TWT ST LEONARDS 23-35 ATCHISON STREET, ST LEONARDS

APRIL 2017

This report has been prepared to address the urban design issues in comments made by North Sydney Council (NSC) in a letter dated 5 April (*CONCEPT FOR 25-35 ATCHISON STREET, ST LEONARDS*) in response to the submission of a preliminary concept proposal on 14 March 2017.

Fig. 4.02 Indicative Master Plan

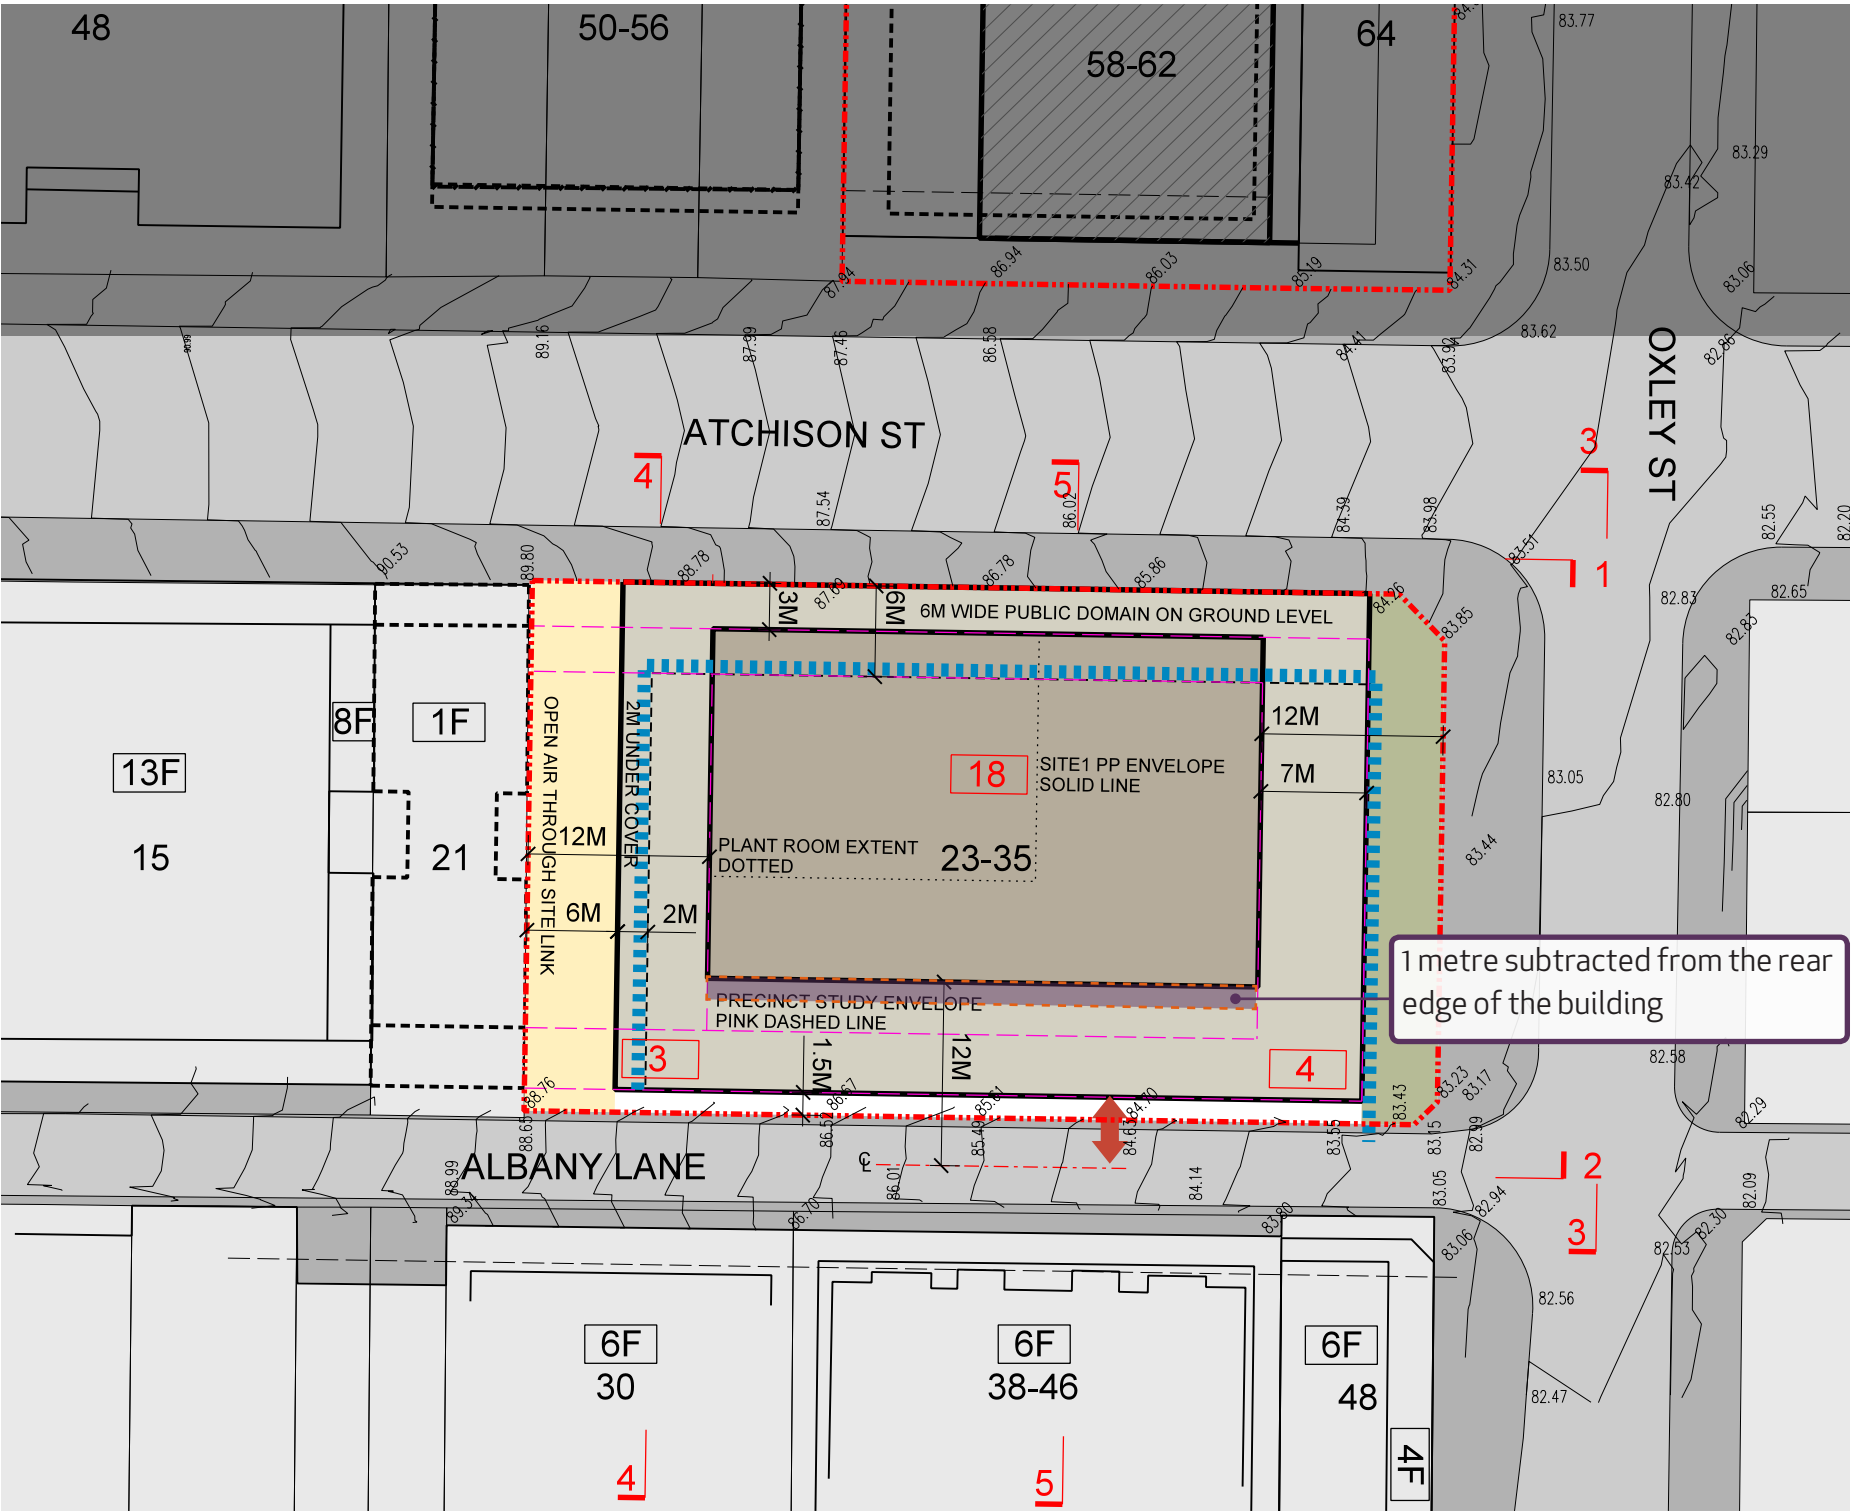
NSC : “Please submit plans at 1:200 at A3 that demonstrate the tower is located at least 12 metres from the centre line of the lane.”

Refer to Fig. 4.02 the revised MASTERPLAN, which shows the 12m setback of the tower from the centreline of Albany Lane and ADG compliant separations to the west boundary.

Master Plan at 1:200 at A3 is provided in Appendix.

Fig. 4.03 Building Envelope Section / Oxley Street Elevation

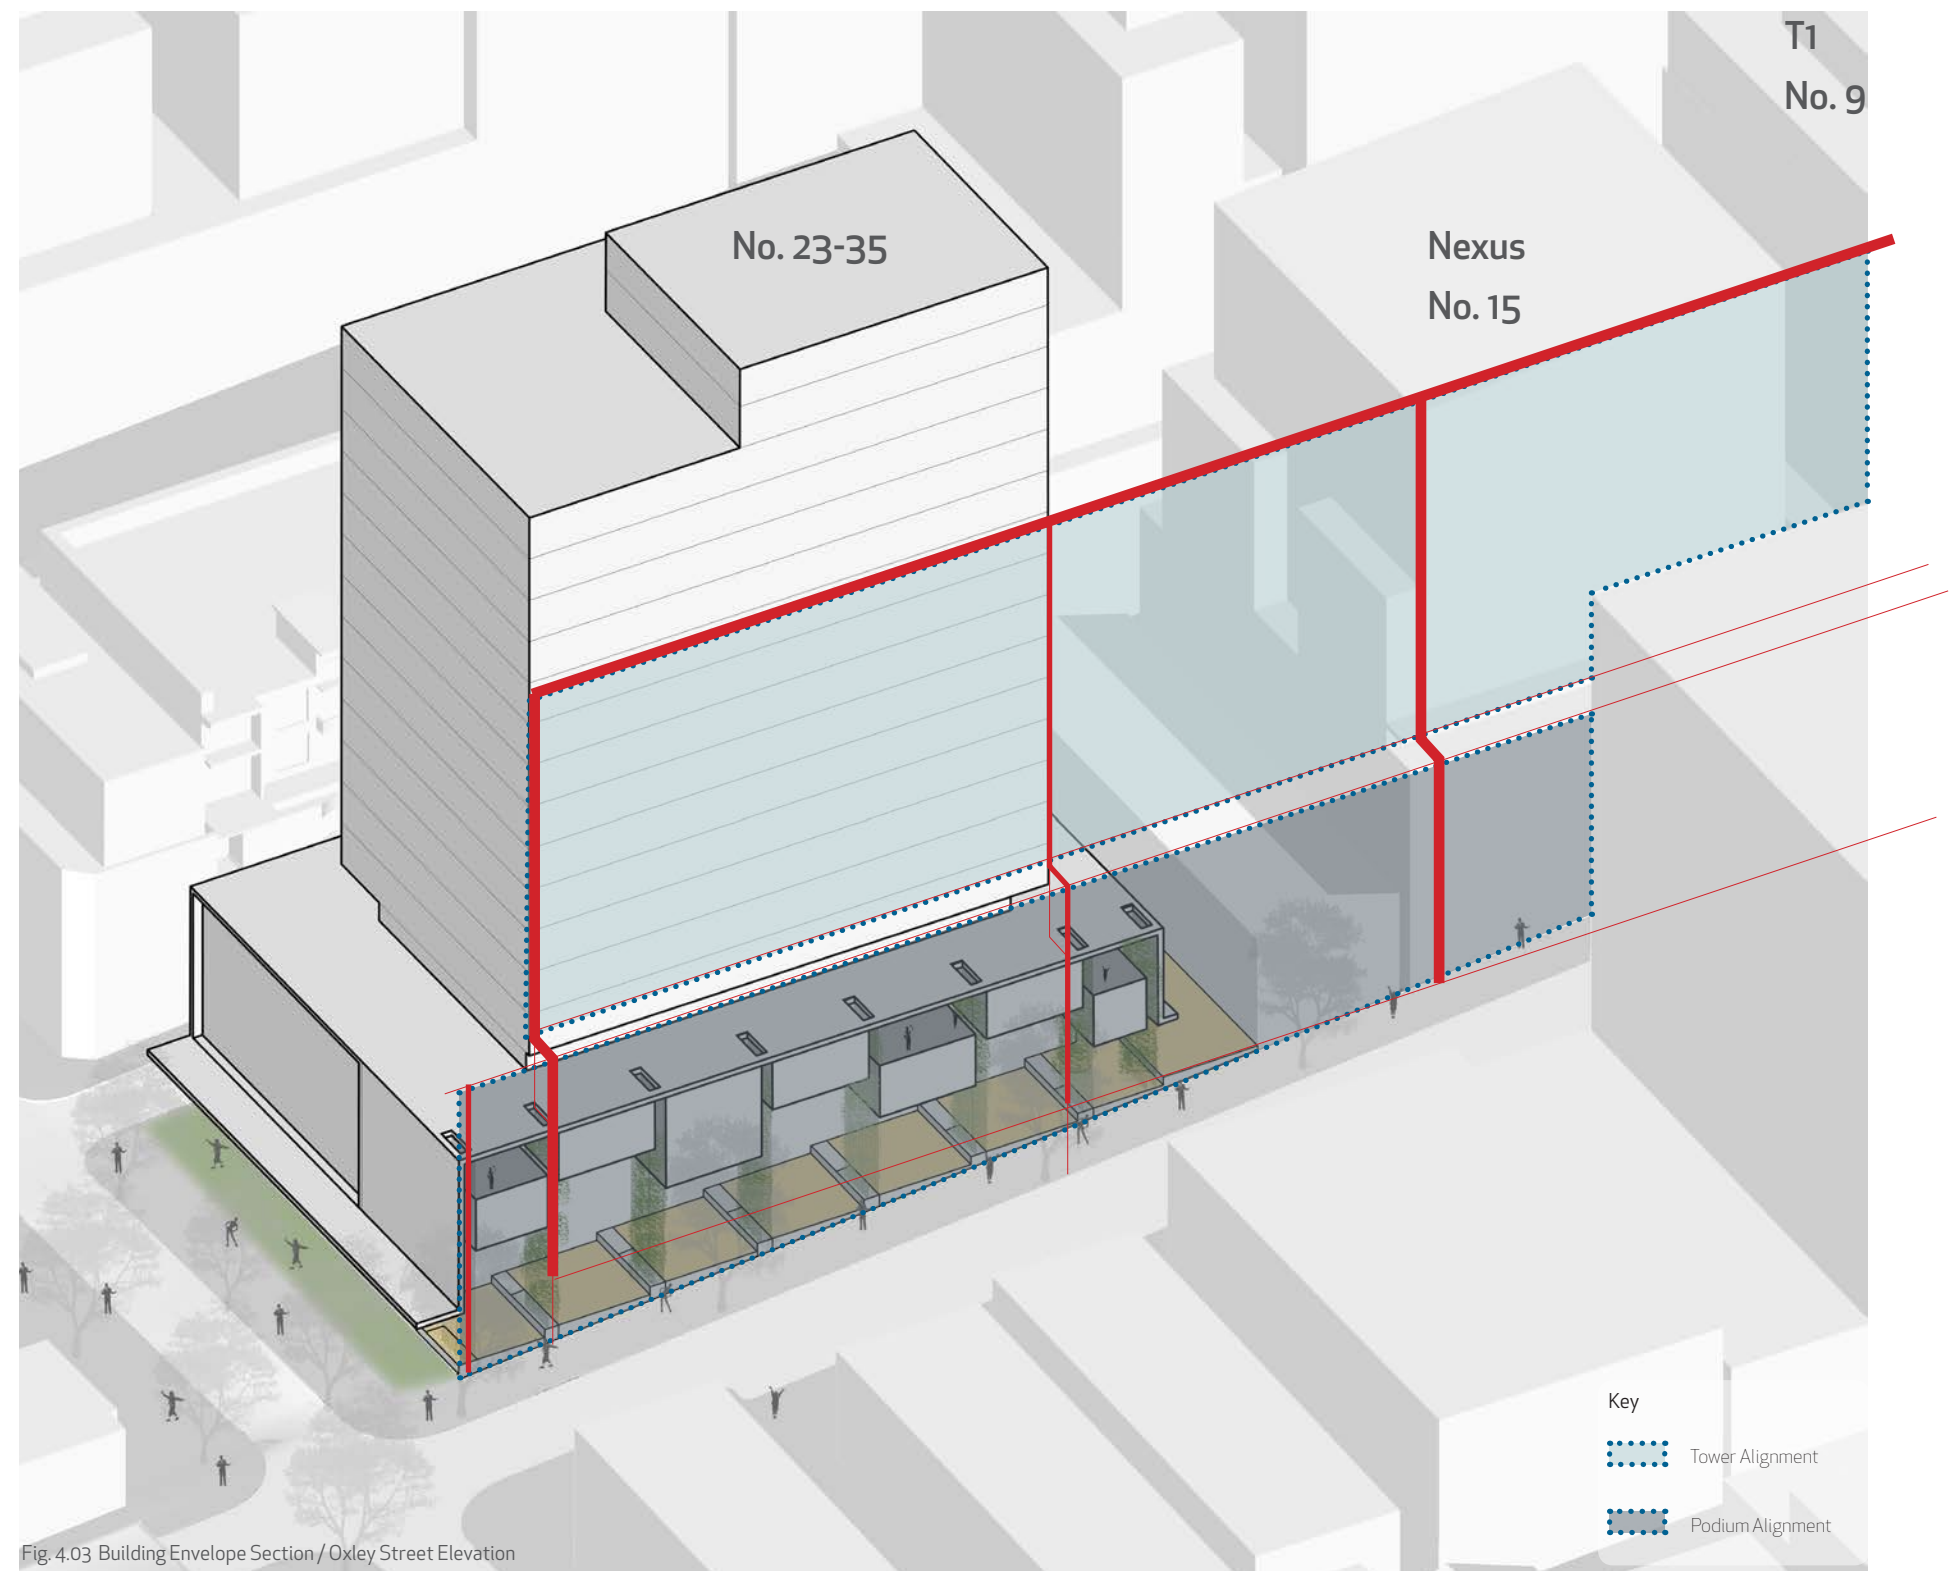
NSC : “Please submit a statement addressing how the built form design will achieve SEPP 65 design considerations.”

The above podium form has been reduced in depth by 1m to 23.1m as shown in Fig. 4.03 the building envelope drawing of the Oxley Street façade.

The scale, bulk and height of the proposal is a response to the desired future character as set out in the height and setback controls in the Planning Study and supports the vision for the North district set out in the Draft North District Plan.

The proposed built form creates, for properties fronting Albany Lane, new vistas and outlooks to new elements of the public domain including the pedestrian through site link and the Oxley Street linear park. In Atchison Street the podium form is designed to align with the existing podium and existing tower setbacks while providing increased setbacks with excellent solar access at ground level to facilitate north facing alfresco dining. The built form footprint will enable a minimum 15% of the site area (316sm) to be retained as deep soil in the pedestrian link and in the linear park.

Fig. 6.01 Proposed Public Domain Diagram

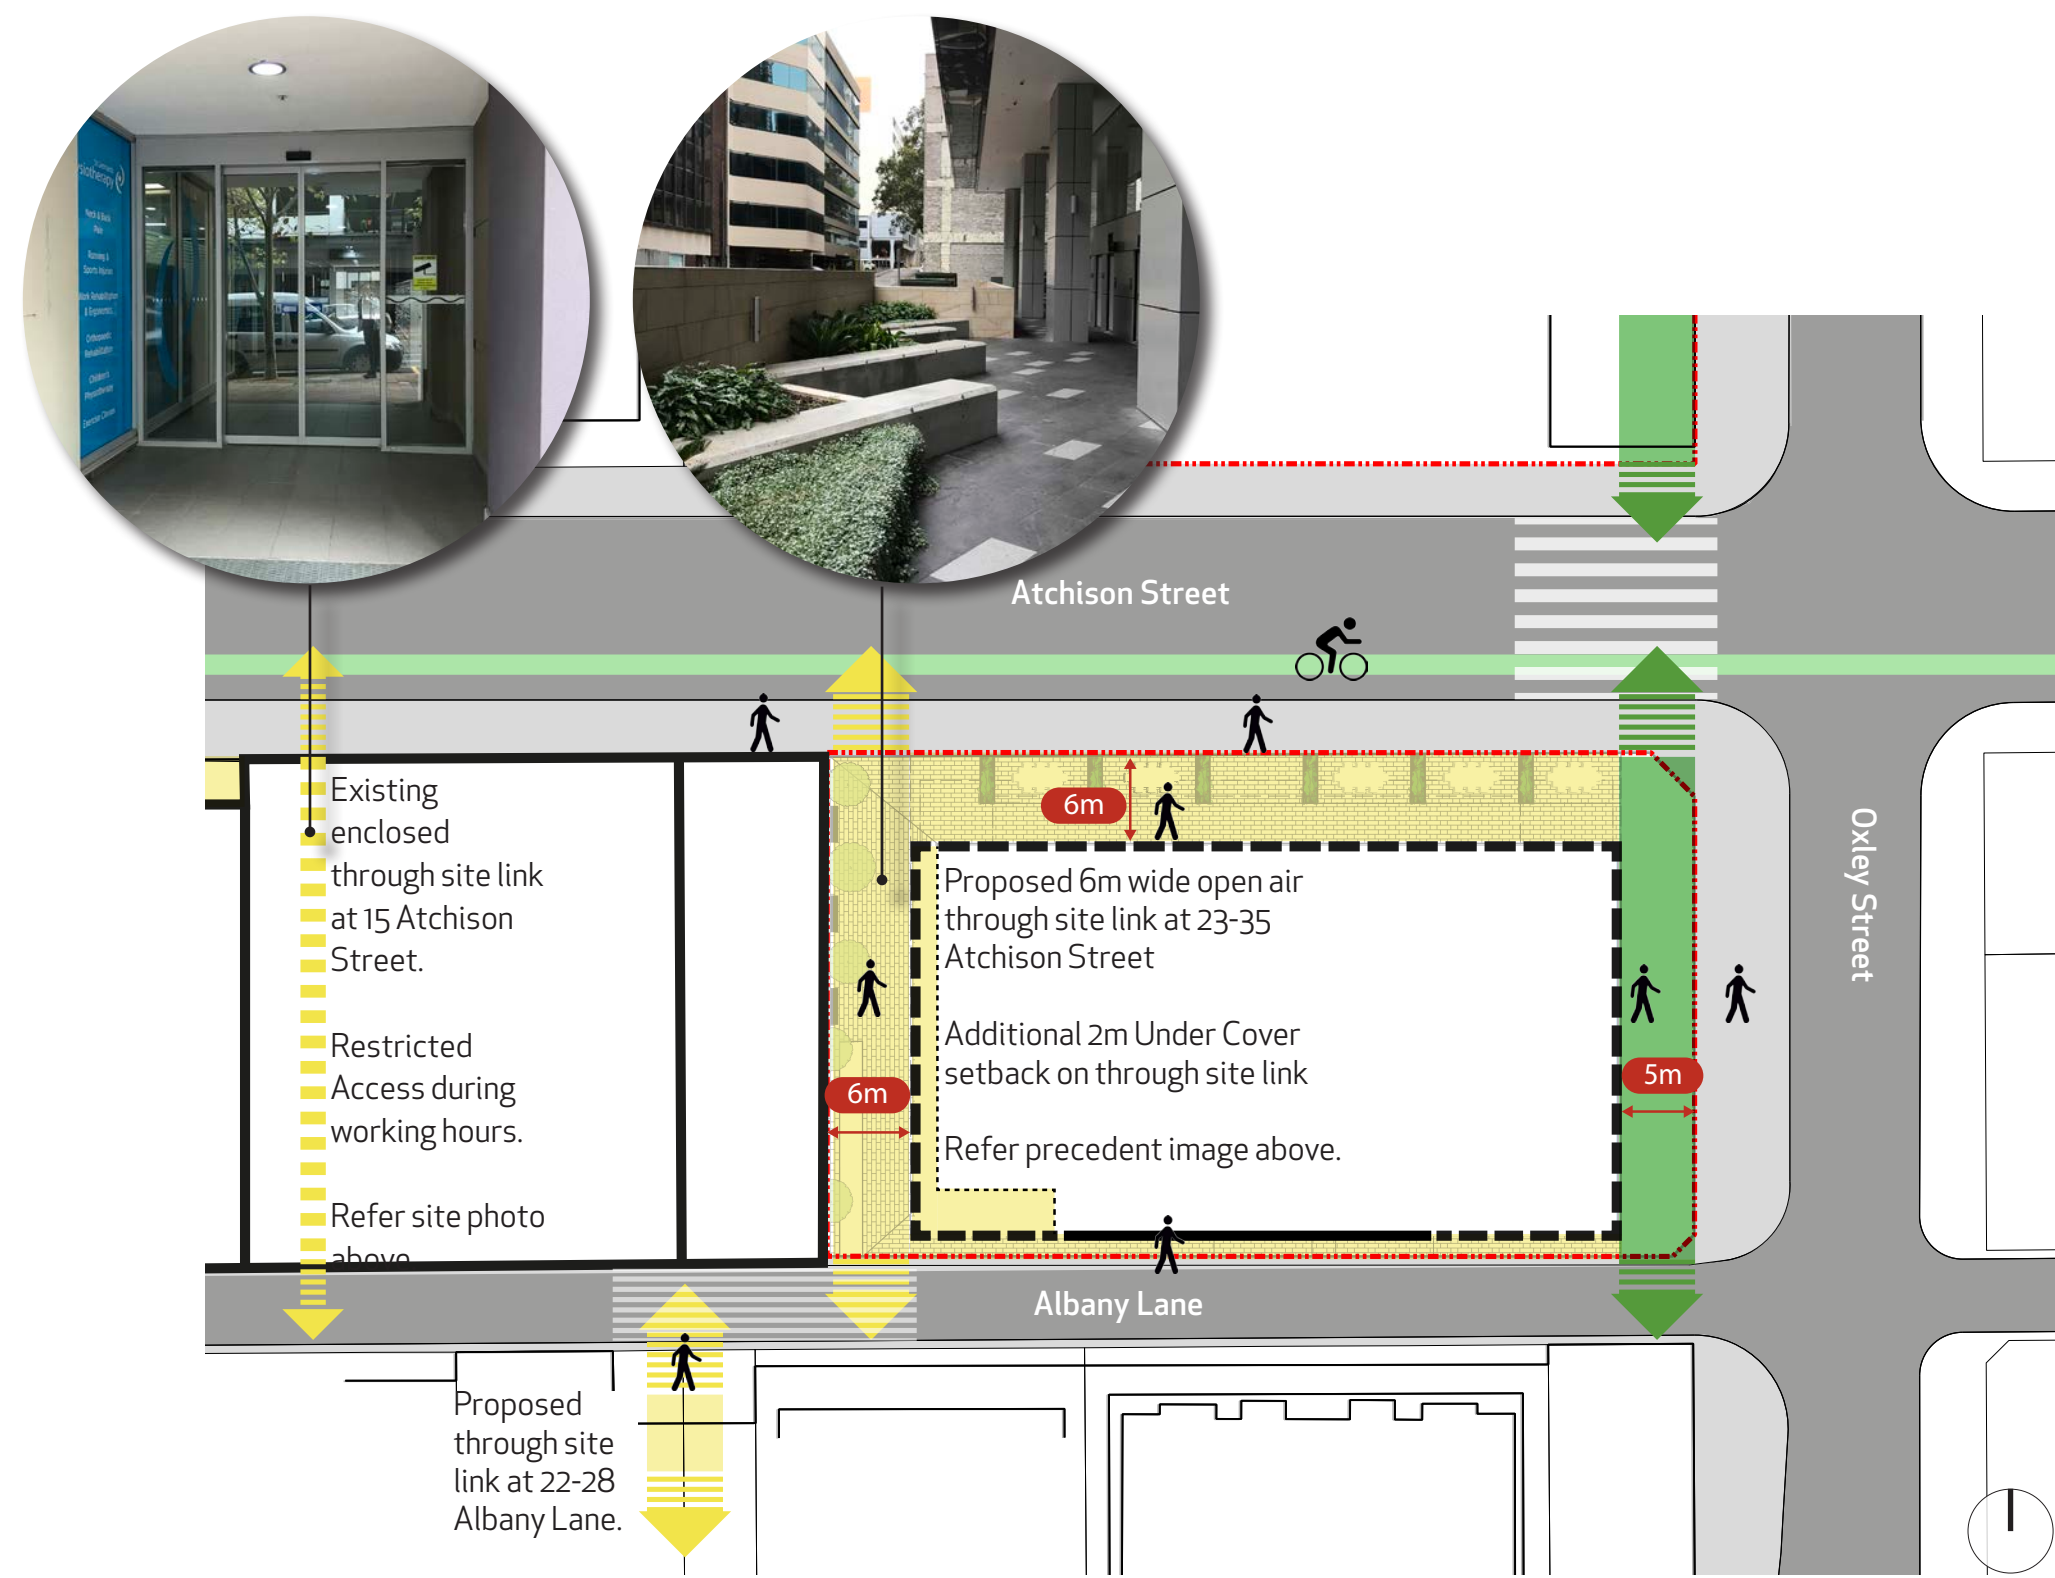
NSC : “The proponent is encouraged to consider the inclusion of an open air laneway, approximately 6m wide, along the western end of the site.”

The proposal has been revised to provide a 6m wide open laneway with an additional 3m setback to the Ground Floor (Upper) shopfronts to provide covered access.
